Re: **Solicitation Addendum # 1 to RFP #25-0350 HBMC STOREROOM DEHUMIDIFICATION AND DUCT RE-INSULATION PROJECT; Exhibit A – Existing Site Conditions; Exhibit B- i-Vu Reference Points.**

This correspondence serves as Solicitation Addendum #1 to the subject Request for Proposals ("RFP").

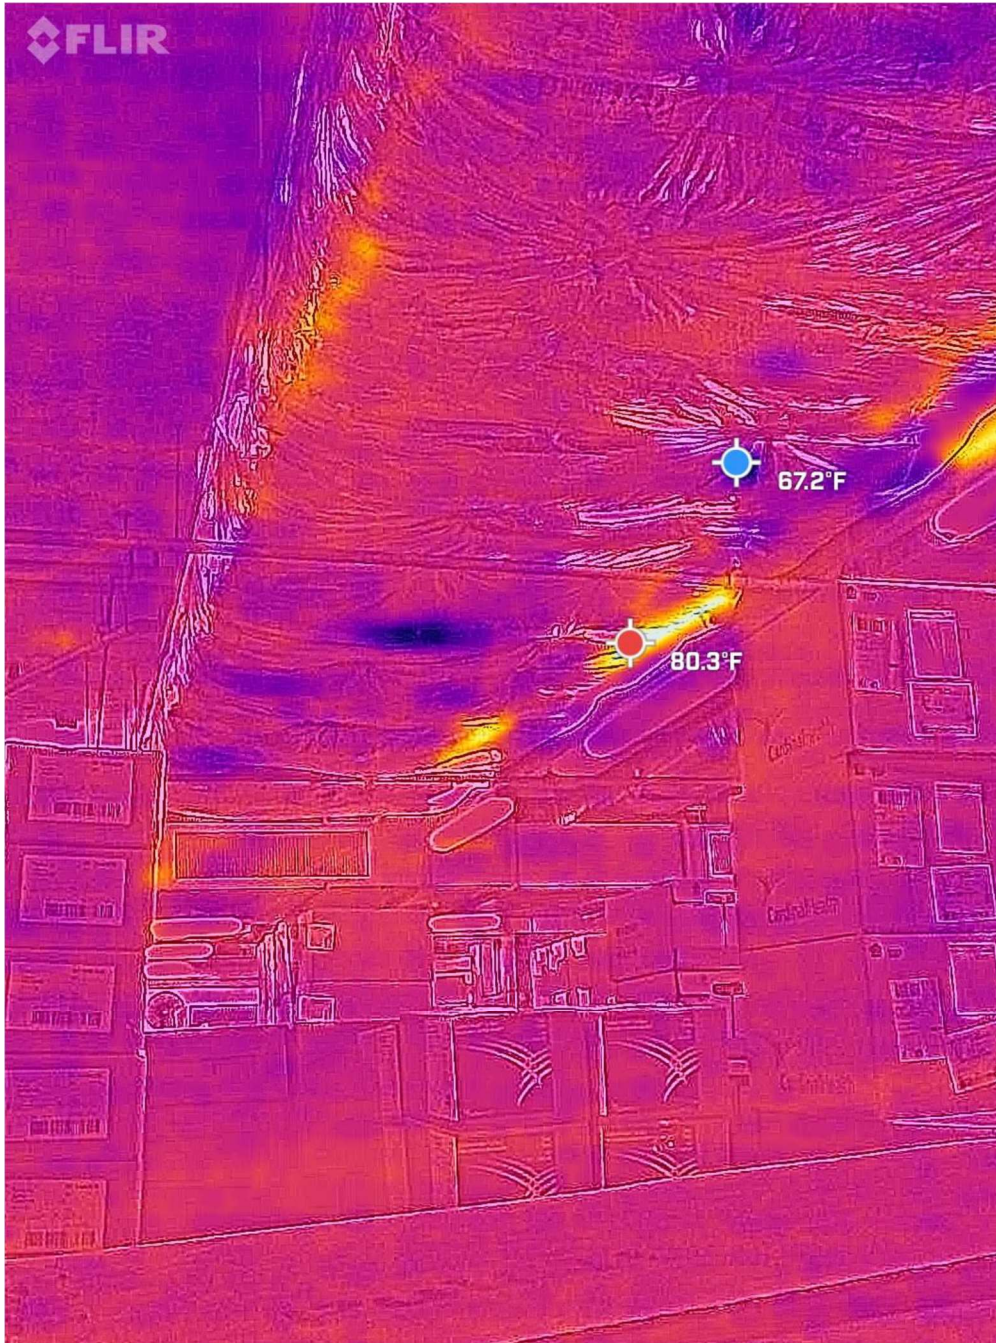
**Q1. What is the current ambient temperature and relative humidity of the storeroom?**

A1. For general reference, please see the attached snapshot, included herein as Exhibit A.

- A7. The project is being undertaken in response to an urgent/emergent situation, and as such, the associated work is intended to be temporary in nature and is classified as emergency work. For general reference, please see the attached snapshot reflecting existing site conditions (Exhibit A).

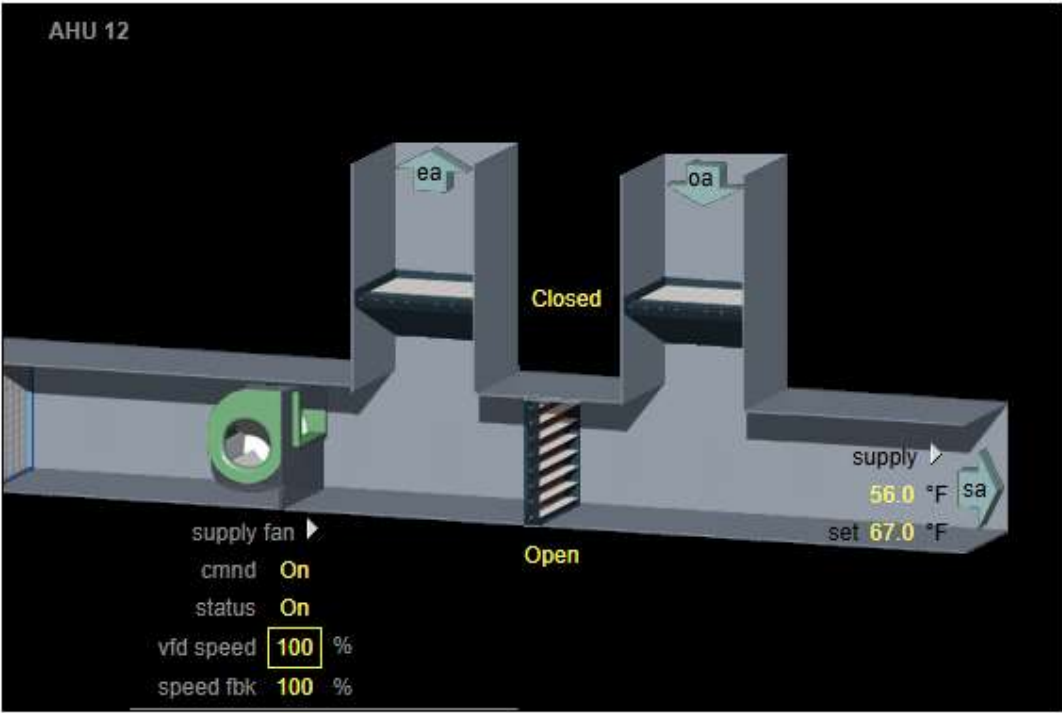
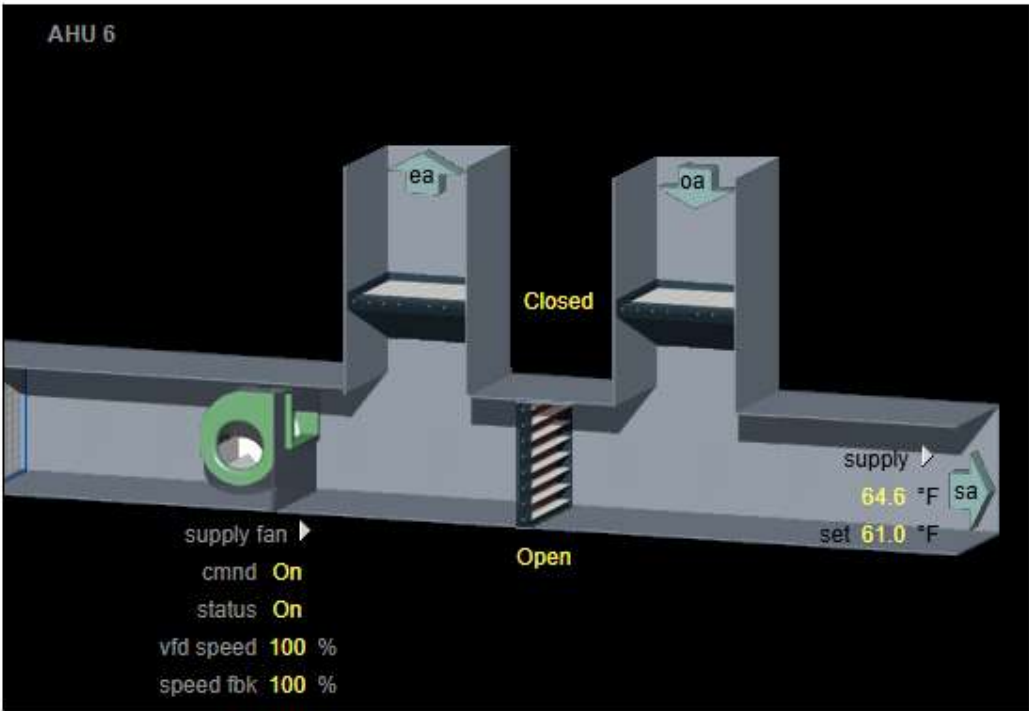
**Q3. What is the current supply air temperature in the existing supply air ducts?**

A3. For reference, please see the attached I-Vu system reference point screenshots, included herein as Exhibit B.
